The City of Spartanburg Design Review Board

AGENDA

SUBJECT
DRB-151 South Church Street

PLANETARIUM EXPANSION AND LEARNING CENTER

BROAD STREET

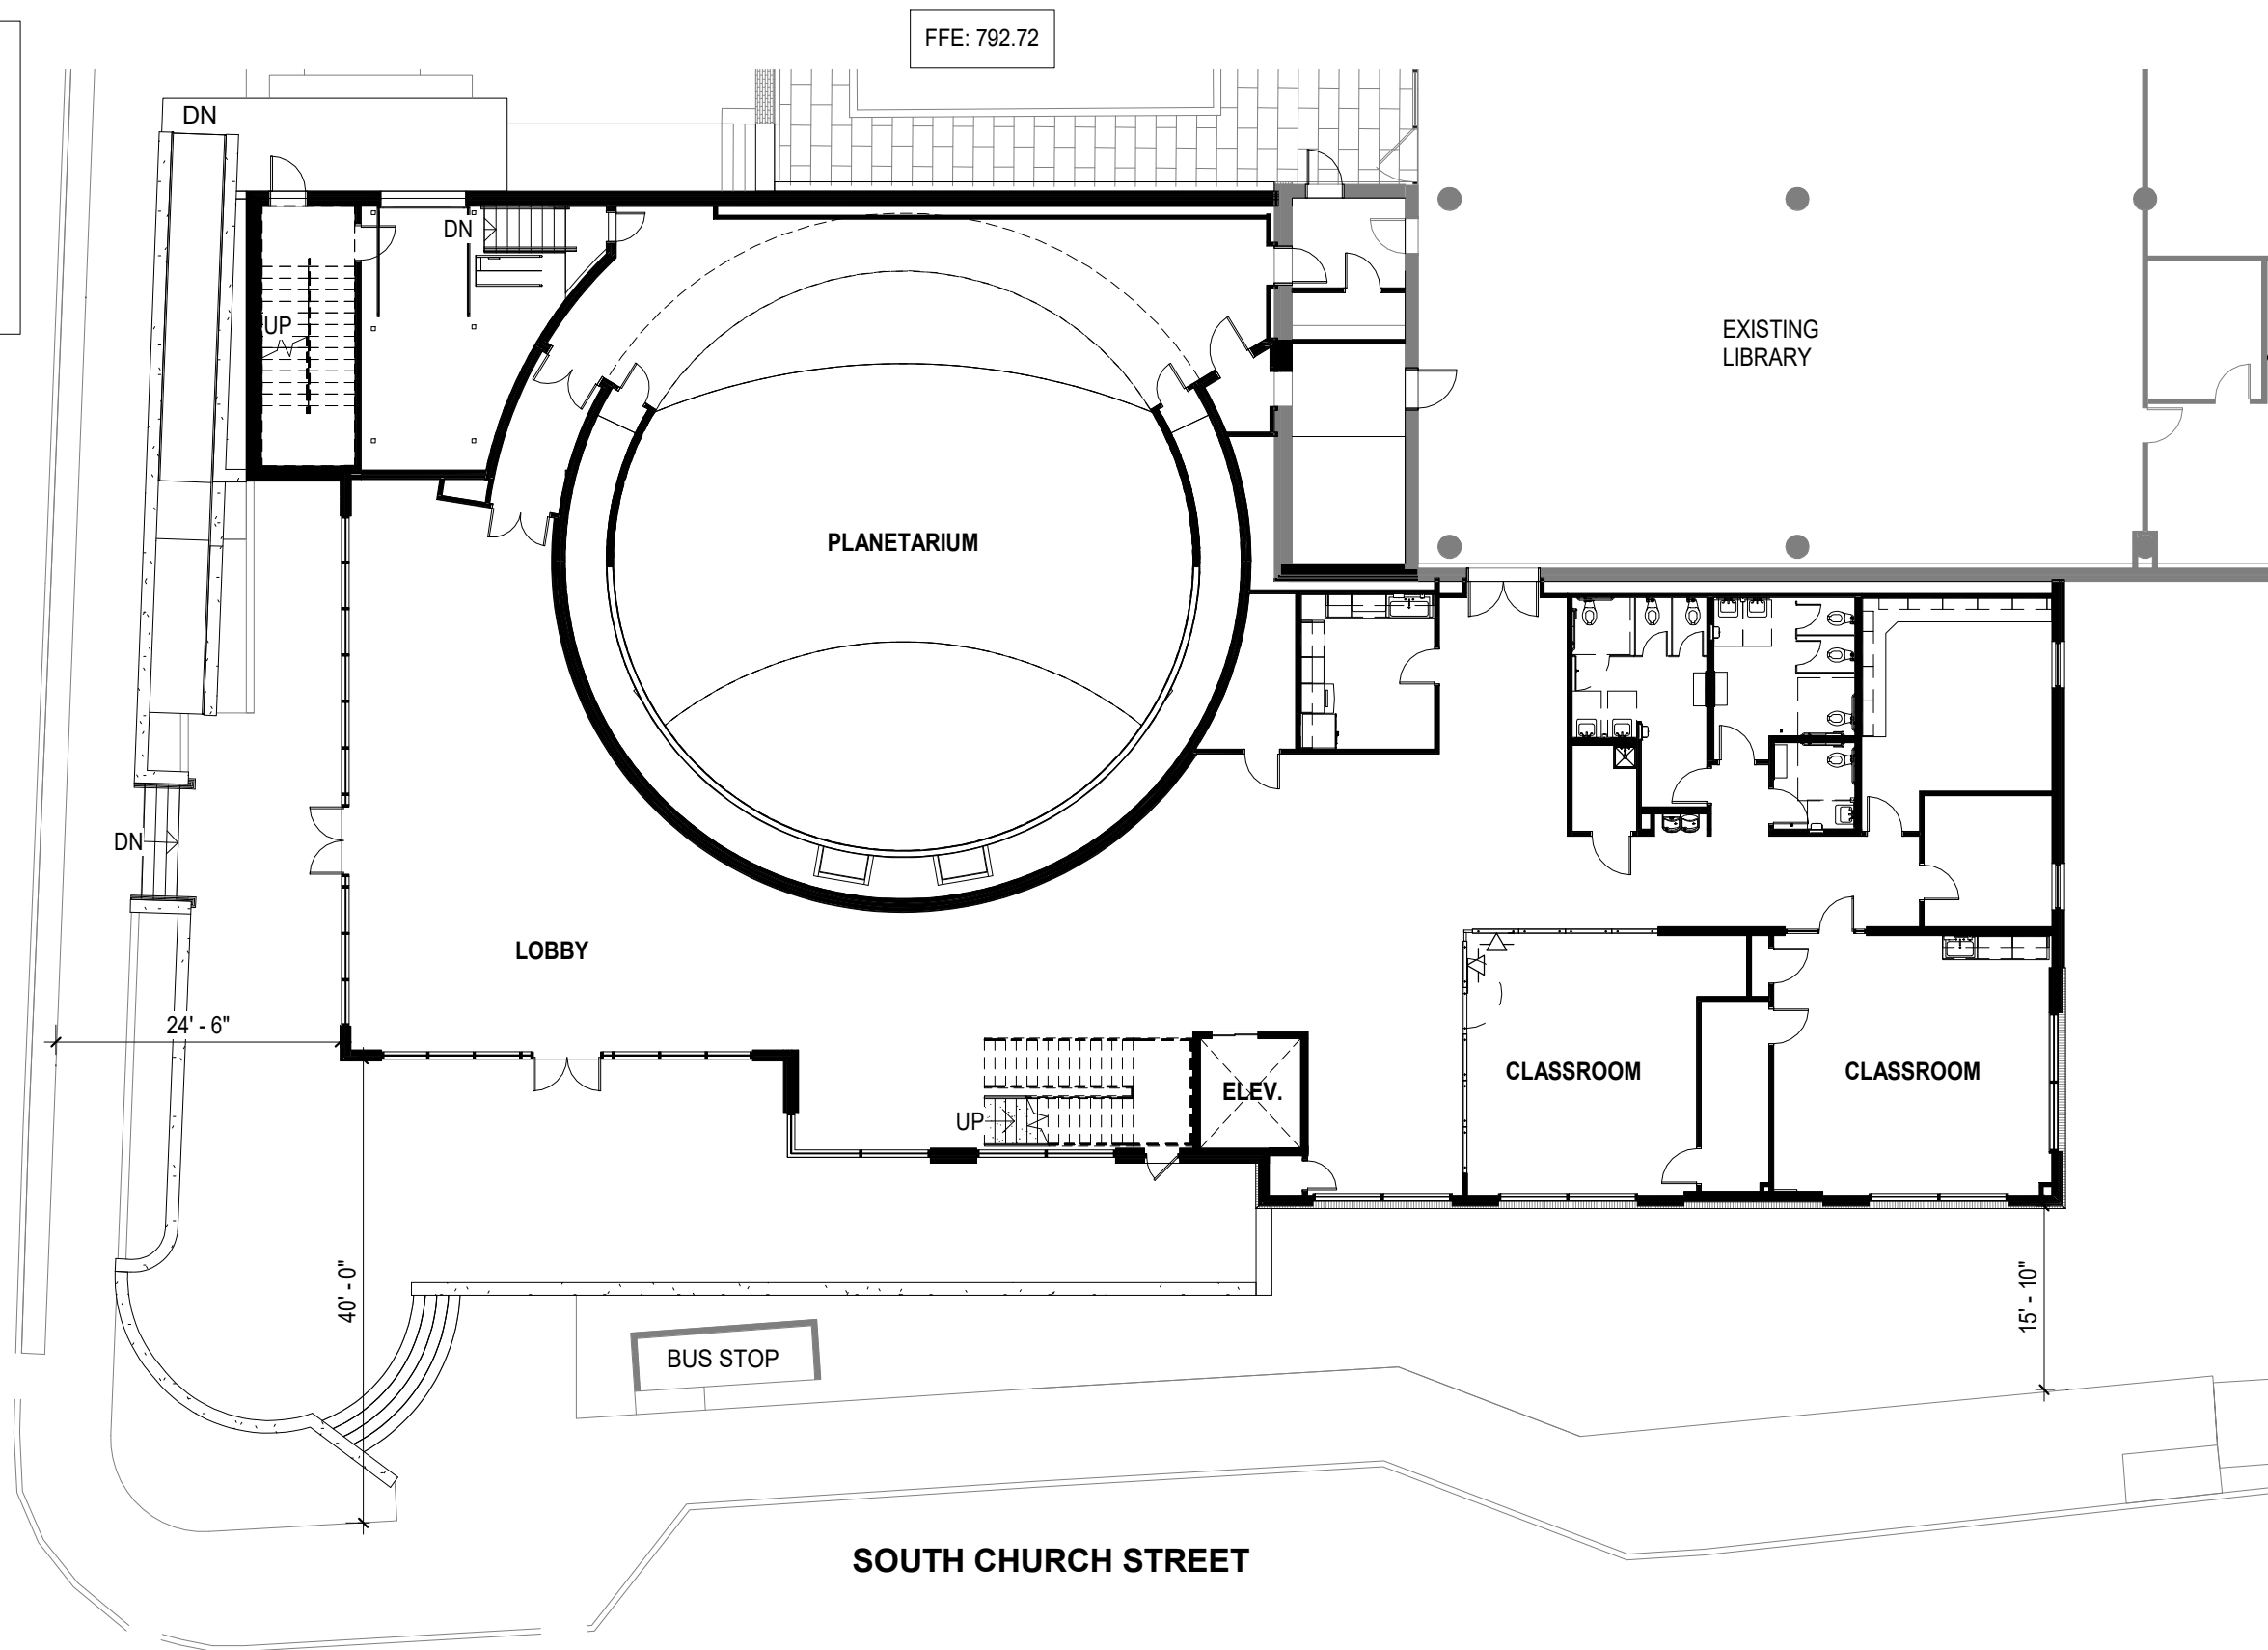
- **Substandard Streetscape along Broad Street and Church Street:** The Broad Street area is rapidly changing and there is a need to improve the streetscape conditions to accommodate the future activities along that corridor. The DT-6 calls for a 16-foot-wide streetscape zone and a 12-foot-wide streetscape zone in DT-5, consistent with the other frontages along Broad Street. Given how many people we expect to be walking along Broad Street, specifically to approach the Library expansion, we do believe that the ideally configuration warrants the DT-6 standard streetscape. However, we do recognize the existing conditions and believe that the 12 foot streetscape section is the bare minimum condition with a goal of trying to retrofit as close to the 16 foot-wide streetscape as possible.

The proposed streetscape condition remains substandard and actually takes a step backward by removing some of the existing trees that provide a buffer between the sidewalk and the roadway. In addition, the proposed hardscape seems to duplicate pathways and inserts retaining walls in the streetscape that unnecessarily segments the overall dimension to create two substandard pathways.

We recommend that this area be reconsidered to consolidate the public sidewalk and private ramp area along Broad Street. Because this is a public infrastructure partnership with the City, we recommend the DRB defer finalization of this requirement to the City staff to achieve a minimum of a consistent 12 foot streetscape. If an exception is still required, staff would bring it back to the DRB.

**SETBACK FROM CORNER AND FRONT
OF LOT**

AS AN ADDITION TO A CIVIC BUILDING
WE ARE ASKING FOR A VARIANCE TO
EXCEED THE 12' SETBACK AND ALLOW
FOR A PUBLIC PLAZA AND PLANTINGS
THAT ACCENT OUR CORNER ENTRY.

FIRST FLOOR PLAN - 1/16" = 1'-0"

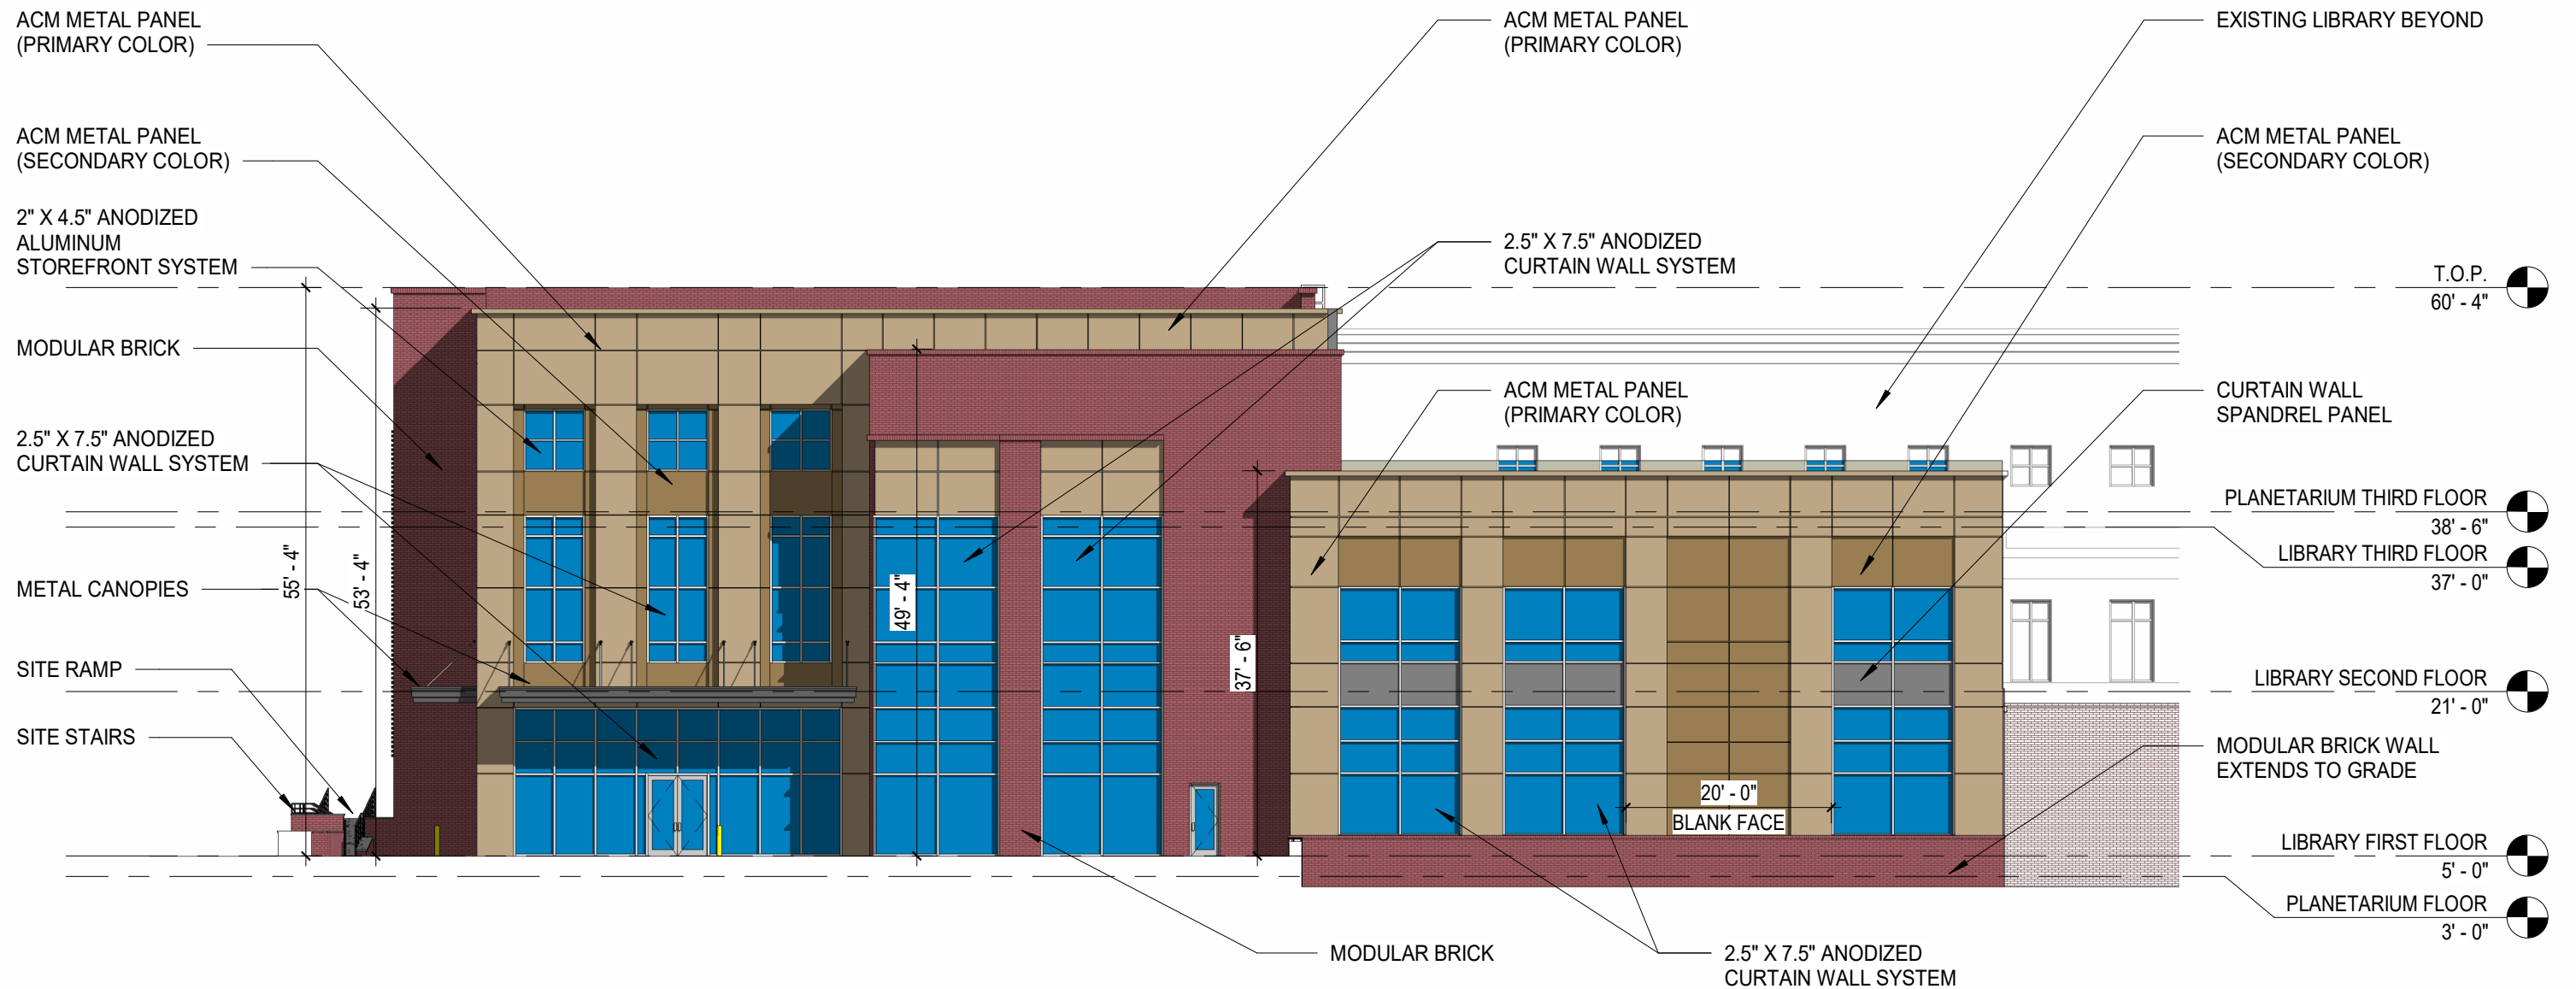
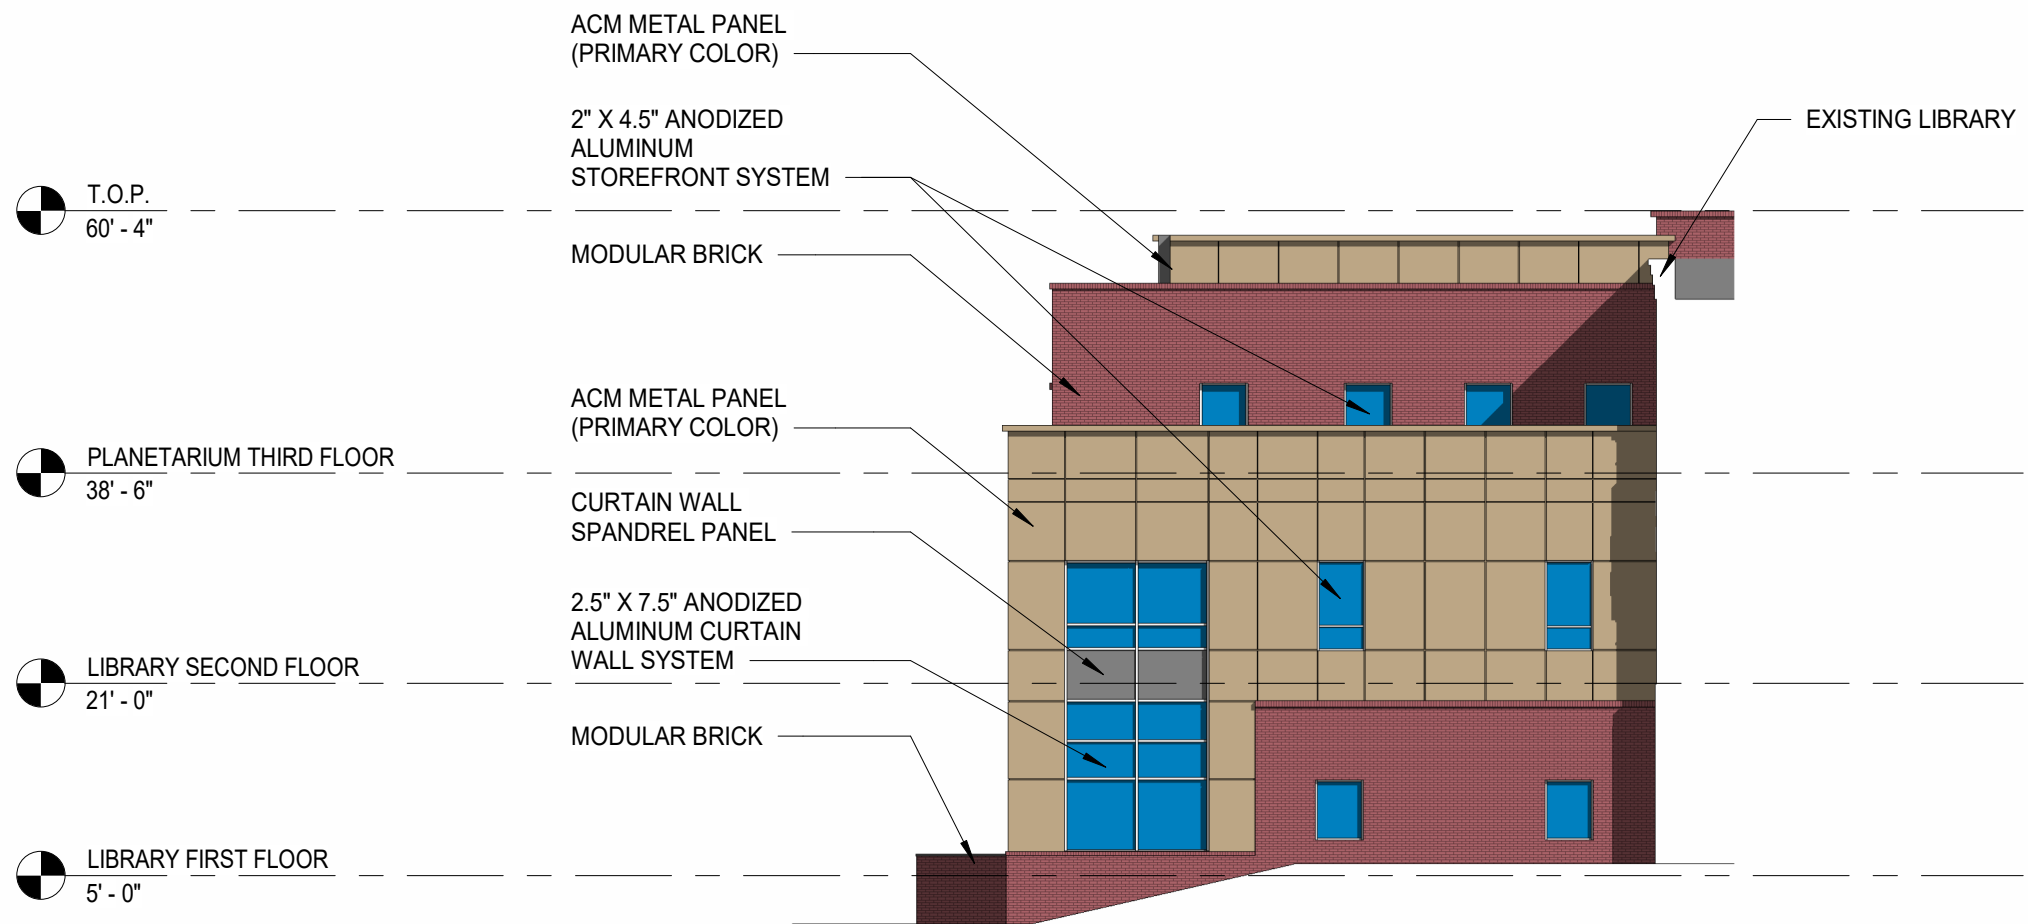
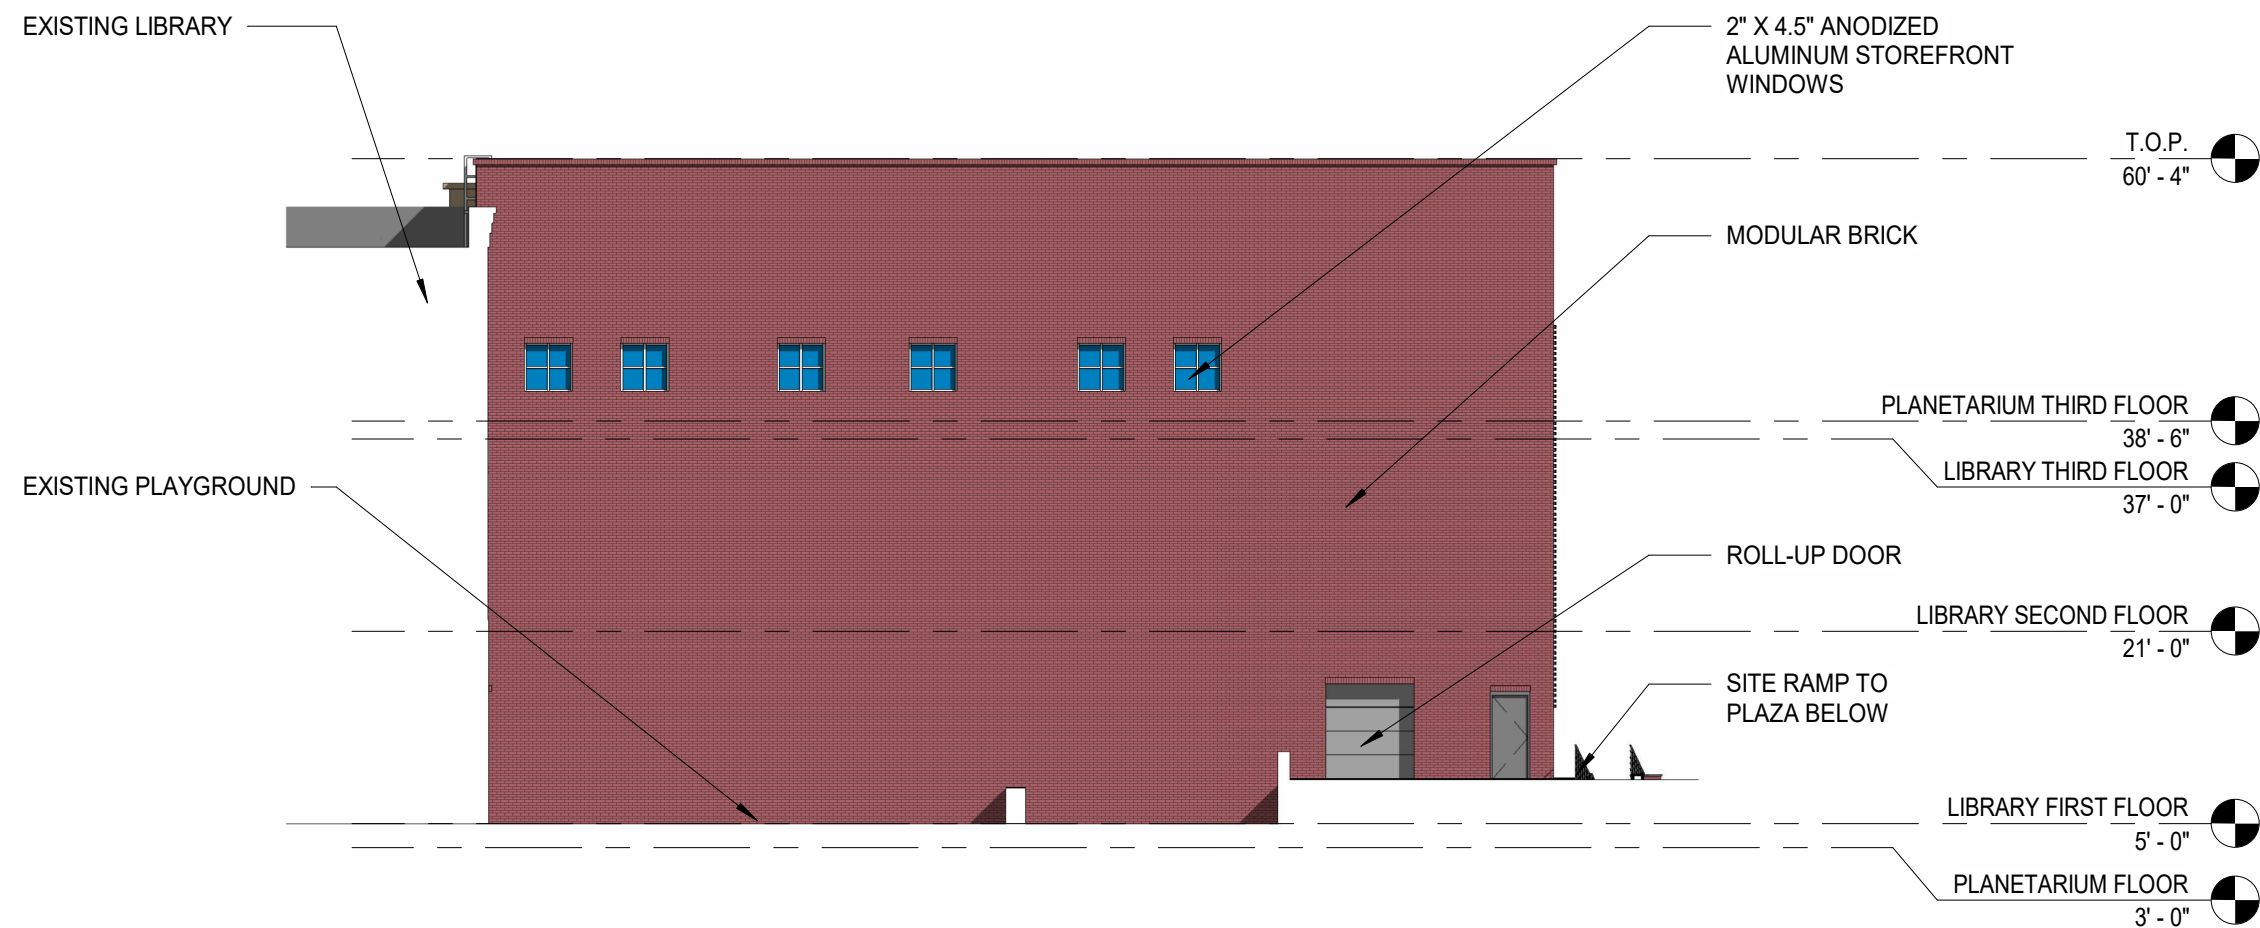
- **Blank Wall Condition along Broad Street:** The proposed 25-foot-wide blank wall along Broad Street contains a stairwell for emergency egress. At their previous meeting, the DRB expressed concern for the proposed condition and requested that the design team consider a treatment to mitigate this condition that could consider the following treatments, or others as appropriate:
 - Windows in the stairwell (presumably fire-rated) – an irregular pattern combined with LED backlighting could make for a very interesting public art element
 - Signage structure on which banners advertising library or community events can be hung
 - A vegetative element such as a green screen (vines trained to grow up the wall) or some foundation plantings
 - A public art component (e.g., applied sculpture, lighting, mural, video wall)

The proposed treatment appears to depict a modular brick pattern that breaks the smoothness of the wall but still utilizes the same brick type and color. We have been told by the applicant that lighting would also be included but as of this writing were awaiting the details. In our view, this is a bit too subtle a treatment, at least what we've seen thus far, relative to other blank wall conditions that have been approved by the DRB.

We recommend that the DRB provide further guidance to the applicant and request that they come back at a later date to review the final design proposal.

BLANK WALL IN EXCESS OF 20' - 0"

WE ARE PROVIDING A BLANK WALL THAT IS 25' - 0" WIDE FACING BROAD STREET TO ALLOW FOR LOADING ACCESS, REQUIRED EGRESS FROM THE UPPER LEVELS, AND TO CONTRAST AND ACCENT OUR CORNER ENTRY SEQUENCE.
